PIC6288A Unable to charge the High voltage battery, DTC P1FFE  
Models

Brand:	Model:	Model Years:	VIN:		Engine:	Transmissions:
			from	to		
Cadillac	CT6 Plug-in	2017 - 2019	ALL	ALL	LGT	MRD

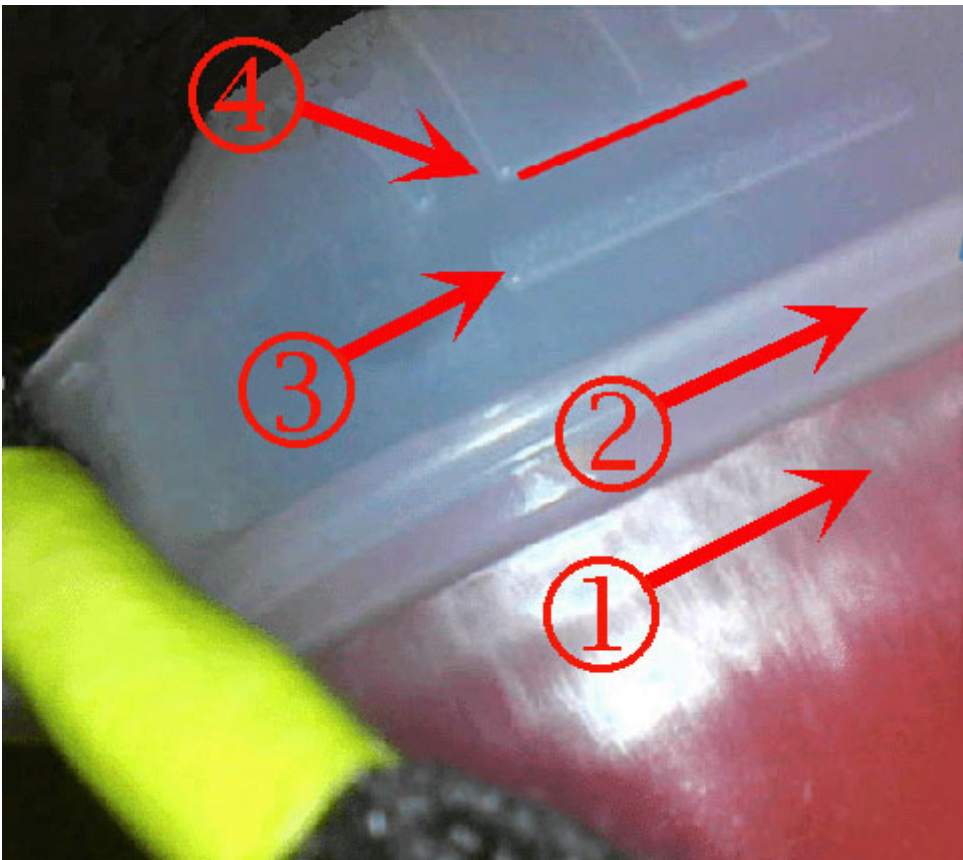
Involved Region or Country	North America
Additional Options (RPO)	HP6
Condition	Customer is unable to charge the HV battery. DTC P1FFE is set when coolant level is at the full indicator line after Hybrid battery pack service or hybrid battery pack cooling system service.
Cause	The coolant level sensor may be stuck, indicating low coolant after Hybrid battery pack service or Hybrid battery pack coolant system service.

- Verify coolant level in tank, Please follow SI for the right steps to check the Level.
  1. Is where it is possible to false low Coolant DTC (Seen in Development)
  2. Low Fill Level
  3. This is the Fill Level Line
  4. Fill to this Level.

- Run Pump using GDS2 and monitor coolant sensor signal
- Run a magnet across sensor on the outside of float to see if signal changes
- If signal changes no further action required, clear codes and test drive the vehicle
- If unable to get signal to change while using a magnet across sensor float replace sensor and do Evac n Fill.

- Although Evac n Fill is not required for level sensor replacement, potential air pockets from previous repairs could be root cause of stuck sensor float.
